Information on the XL T@G / 5W T@G chassis

2016 – 2018 XL T@G / 5W T@G

T@G TECHNICAL SERVICE BULLETIN

P/N 20100408

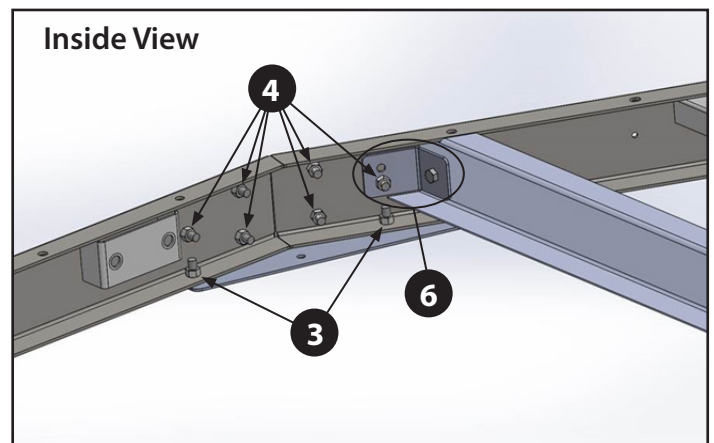
It has been determined that a few of the XL T@G / 5W T@G trailers have been strapped down too tightly to the flatbed truck during transport causing a few of the chassis to crack. Therefore, dealers / owners should inspect the chassis of their trailers. If cracks are found, see repair procedure.

If the dealer / owner describes the symptom/condition above, repair procedure is needed. If the crack is more than 10% the height of the chassis member or greater than 1/16" apart, the chassis will be replaced at no cost. If either of those instances are not met, then the repair procedures listed below will be performed at no cost.

1. Position Reinforcement Bracket to outside of Frame Rail.
(Roadside Rail shown. Repeat for Curbside.)
2. Clamp Reinforcement to the Rail so both surfaces are tight against the sides of the Rail and to the bottom flange.
(Bend in Rail and in Reinforcement are lined up with each other)

3. Attach Reinforcement to the bottom flange of the Frame Rail through two existing holes in Rail using supplied 3/8" hardware.
4. Using a 3/8" Drill bit, transfer the six holes from the Reinforcement Bracket into the vertical web of the Frame Rail and fasten with supplied 3/8" hardware.

5. Transfer one hole at the front of the Reinforcement through the bottom flange of the Rail and fasten with supplied 3/8" hardware.
6. Locate Angle Plate to inside of the Frame Rail with forwardmost hole drilled in Step 4. Transfer hole into Cross Member and attached with supplied 3/8" hardware.

7. Torque all fasteners to 33 ft-lbs.
